Wiring Changes for the new Centurion (MV-5-C) display

Please observe the wiring changes below when exchanging the old C4-3 Centurion display with the new MV-5-C display:

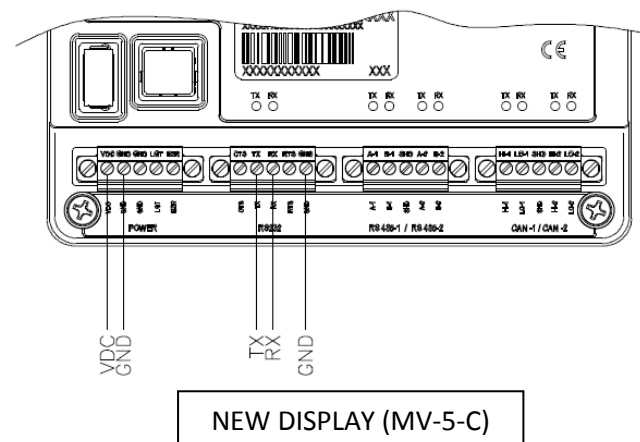
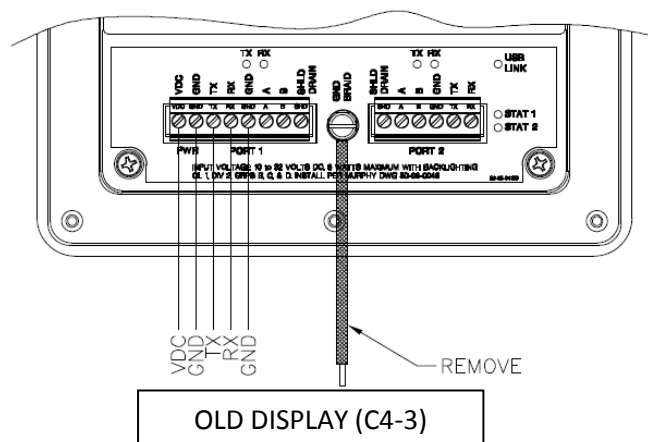
1. The wiring ports are isolated in the new display, and the connectors are held by screws. Please observe the name printed for each terminal. Example: VDC, GND, TX, RX, etc.
2. For your convenience, a screwdriver is provided with the new display to work on the terminal block screws.
3. VDC and GND for PWR terminals on PORT 1 of the old display should be connected to VDC and GND of POWER port on the new display.
4. TX, RX, GND from PORT 1 of the old display is wired to TX, RX, GND on RS232 port of the new display.
5. If you have a braided GND wire on the old display, it is no longer needed on the new display. It can be safely terminated.
6. Recycle power and the new display should start to sync with the controller.
